**RE: Opportunity to Address Comments Received for Agnico Eagle Mines Limited's  
*Meliadine Gold Mine Project 2021 Annual Report***

Agnico Eagle Mines Limited thanks the Nunavut Impact Review Board (NIRB) for the opportunity to address comments received for Agnico Eagle Mines Limited's Meliadine Gold Mine Project 2021 Annual Report.

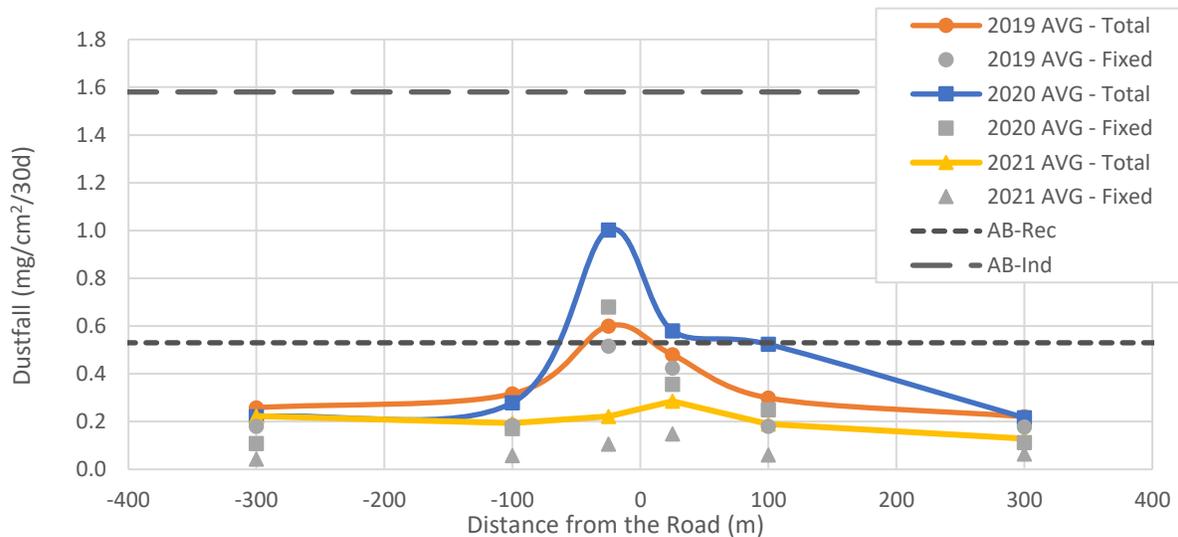
### Comment

Agnico Eagle appreciates and agrees with ECCC's comment that precipitation may have also influenced road dust generation in 2021. Agnico Eagle understands that in fact, many environmental factors such as precipitation, temperature, and wind speed can influence rates of fugitive dust, in combination with use scenarios, road material, and dust suppressant application. For clarity, the objective of this report with regards to road dust is to document current conditions and trends in measured dustfall, and indicate the best management practices that are in place to help minimize dust generation. While a basic commentary on potential reasons for observed trends is provided, Agnico Eagle notes that rates of dustfall are assumed due to a complex interaction of the above-mentioned factors. These factors have well-established relationships used in air quality modelling, and any validation of those relationships is beyond the scope and design of this monitoring program.

Nevertheless, Agnico Eagle has conducted a basic review of summer precipitation rates in relation to dustfall results since 2019 when roadside transect sampling began. Precipitation recorded by the Rankin Inlet weather station was reviewed, since automated precipitation monitoring didn't begin at Meliadine until 2020. As ECCC indicates in their comment, total summer precipitation in 2021 was greater than 2020 (Table 1), which in isolation would lead to a reduction in fugitive dust year-over-year. However total precipitation in 2019 was greater than 2020 and 2021, yet measured average dustfall was not lowest in 2019 (Figure 1), indicating that, as would

Figure 1. Orthophosphate concentrations (mg/L) in Meliadine Lake from 1997 to 2021.

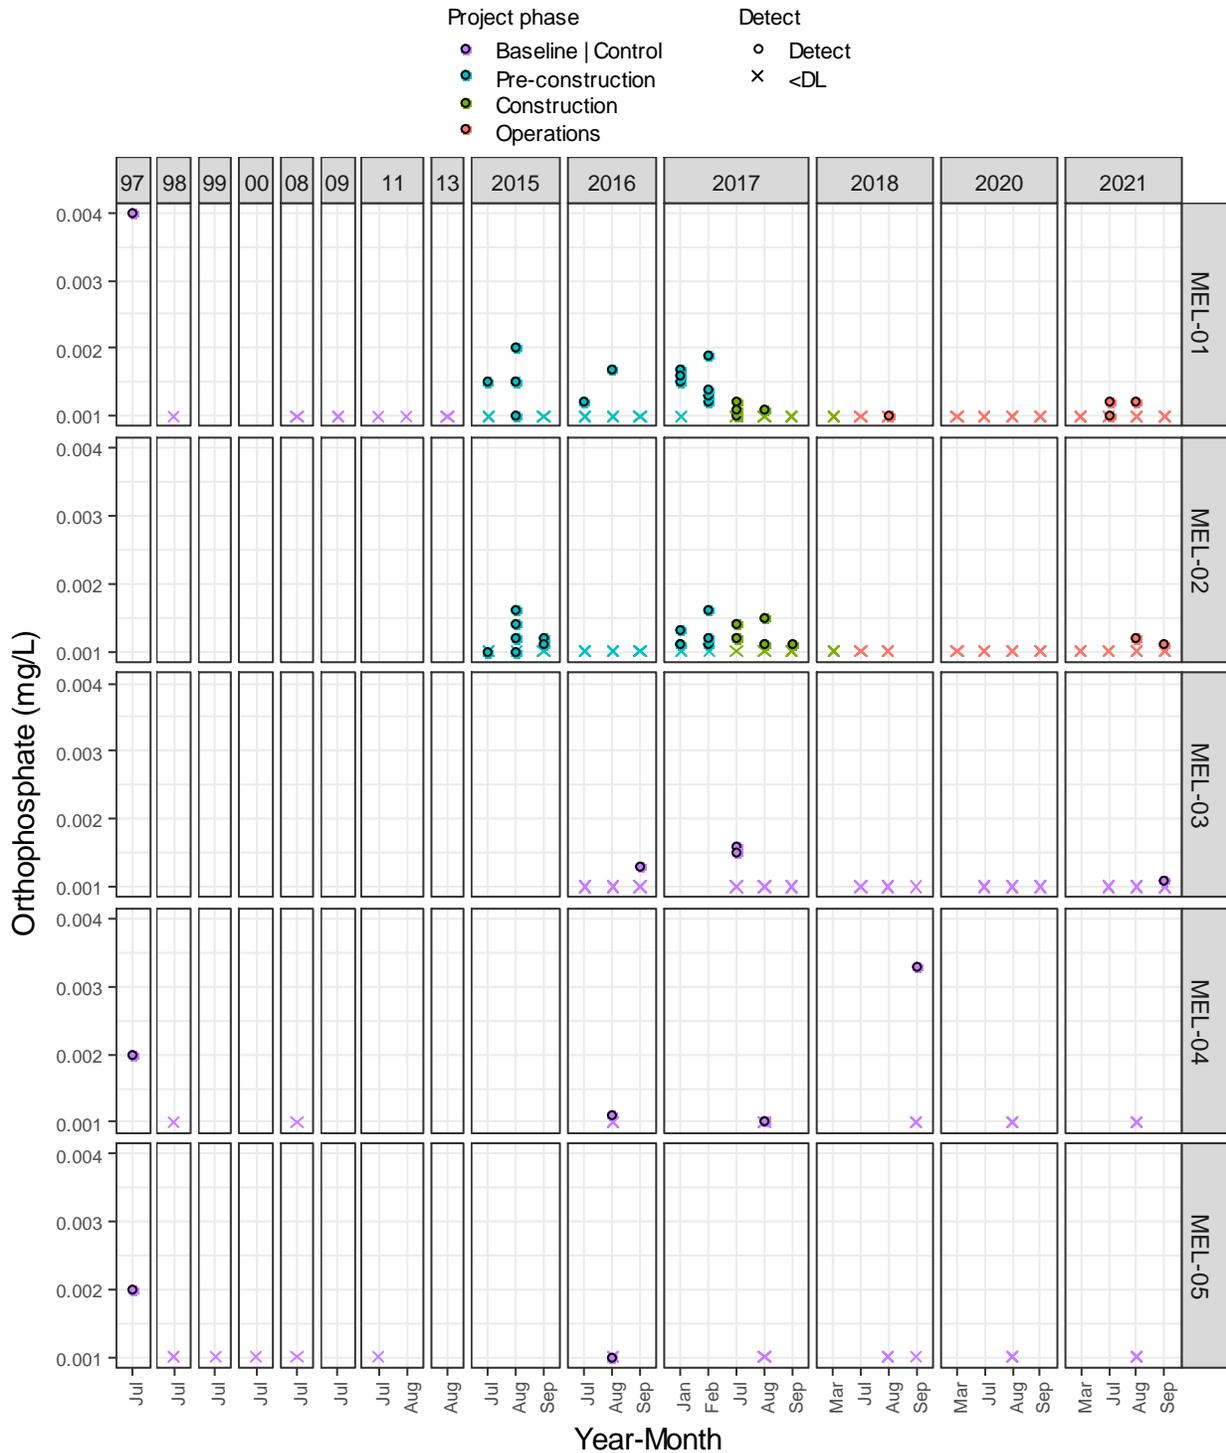
### Comment

Total phosphorus concentrations have, in general, increased since the baseline period from the lower end of oligotrophic status (0.004 mg/L) to near the AEMP Action Level of 0.0075 mg/L. There is, however, some uncertainty about the natural range in phosphorus concentrations in Meliadine Lake given sparse and highly variable data collected during the baseline period (Figure C2-23). In 1997, the concentration reported in the East Basin (MEL-01) in July was at the upper limit of oligotrophic status (0.01 mg/L). Furthermore, phosphorus concentrations have periodically exceeded the upper limit of oligotrophic status at the reference areas. For example, phosphorus was measured at 0.03 mg/L in the samples taken in the Northwest Basin (MEL-04) in July 1997. Near the outlet of Meliadine Lake to the Meliadine River (MEL-05), 5 of the 7 samples collected in July from 1997 to 2011 had phosphorus concentrations that were equal to or greater than the AEMP Action Level. On a lake-wide basis, phosphorus concentrations have typically measured within the range of oligotrophic status (0.004 mg/L to 0.01 mg/L), but the use of 75% of the upper limit of oligotrophic status as the AEMP Action Level means we can likely expect periodic exceedances of the AEMP Action Level at MEL-01 in the future. It's important to emphasize that phosphorus loadings decreased significantly after the sewage treatment plant at the main camp came online in November 2017.

Based on the available data from water chemistry and phytoplankton monitoring programs, the concentration of total phosphorus in water samples is a relatively weak line of evidence for deciding if effluent is causing nutrient enrichment and effects to primary productivity.

Phytoplankton community endpoints such as total biomass and chlorophyll-a are a better indicator of whether effluent is causing nutrient enrichment and effects to primary productivity. As mentioned in Section 7 of the 2021 AEMP report (Phytoplankton), phosphorus and nitrogen concentrations in surface water do not appear to be strongly influencing phytoplankton biomass or chlorophyll-a based on data collected at the NF, MF, and reference areas in Meliadine Lake since 2013 (Figure 6.9). Most of the phosphorus in freshwater occurs as organic phosphates, cellular constituents of organisms, and within or adsorbed to inorganic and dead particulate organic matter (Wetzel 2001). Among the various chemical forms of phosphorus in freshwater systems, orthophosphate is the only form of soluble inorganic phosphorus directly utilized by aquatic biota<sup>1</sup>. Challenges with accurately estimating orthophosphate, combined with rapid turnover, means total phosphorus is typically recommended as the default parameter to include in monitoring programs. Nonetheless, orthophosphate concentrations at the near-field and mid-field exposure areas are typically below the limit of detection (see figure below). Orthophosphate was more routinely detected at MEL-01 and MEL-02 from 2015 to 2017 before sewage from the Exploration Camp was diverted to the sewage treatment plant at the main camp.

As ECCC points out, there is some evidence that the East Basin of Meliadine Lake is more productive than the reference areas, particularly when looking at the chlorophyll-a data in 2021. Threespine Stickleback in the exposure area are also heavier for a given size compared to fish from the reference areas. The Threespine Stickleback results are explored in greater detail in the Cycle 2 EEM Interpretive Report (in preparation), but preliminary results show that the differences in condition between the exposure and reference areas for male and female fish, for both parasitized and unparasitized populations, are less than the critical effect size of 10%. According to Environmental Effects Monitoring (EEM) guidance, effects less than critical effects sizes (CES) are unlikely to adversely affect the health of the fish population.
